Intel® 82598 Power Supply Sequencing/Power On Reset/ LAN_PWR_GOOD Design Clarifications

December 2008

This document describes the power supply sequencing and the Power On Reset (POR)/LAN_PWR_GOOD design clarifications for the 82598 10 GbE controller.

Figure 1. 82598 Power Supply Sequencing Diagram

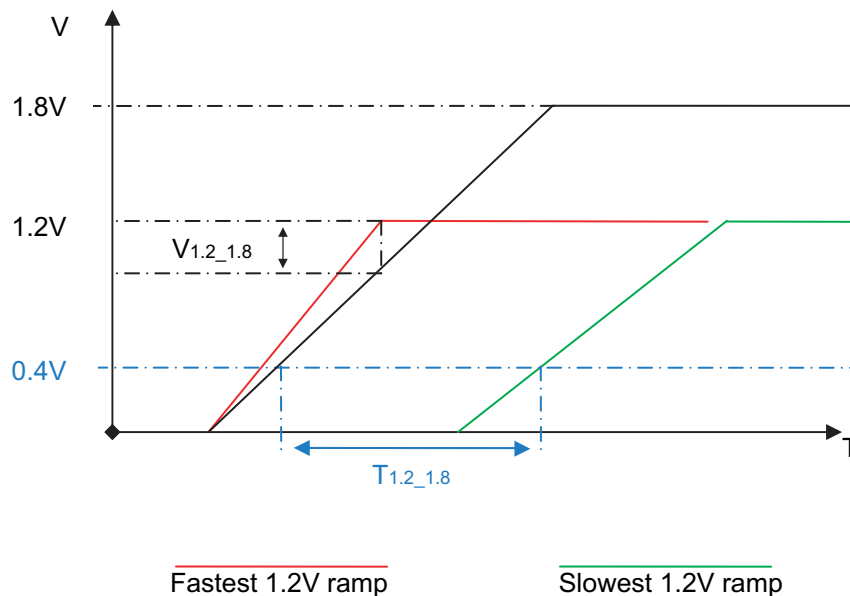
Intel has made several updates/clarifications to the *Intel® 82598 10 GbE Ethernet Controller Open Source Datasheet*, and recommends that designers follow the summary steps below to assure that the Intel® 82598 is properly initialized and does not subject the silicon to latch-up and/or forward biasing the internal ESD protection diodes.

- +3.3 V dc rail:
 - 3.3 V dc must come up first.
- +1.8 V dc rail:
 - 1.8 V dc follows 3.3 V dc and must come up* no sooner than 10 μ s and no later than 100 ms after 3.3 V dc.
- +1.2 V dc rail:
 - 1.2 V dc follows 3.3 V dc and must come up* no sooner than 10 μ s and no later than 100 ms after 3.3 V dc.
 - If 1.2 V dc rail ramp is leading 1.8 V dc; 1.2 V dc must not be more than 0.3 V (max) voltage difference from 1.8 V dc (for the entire ramp duration). See the following diagram.
 - If 1.2 V dc rail ramp is lagging 1.8 V dc; 1.2 V dc must not lag 1.8 V dc by more than 0.5 ms (when measured at 0.4 V dc). See Figure 1.

Note: If board designers have difficulty meeting this parameter, use the LAN_PWR_GOOD (external) timing parameter instead.

Note: * measured at 90% of final nominal voltage amplitude.
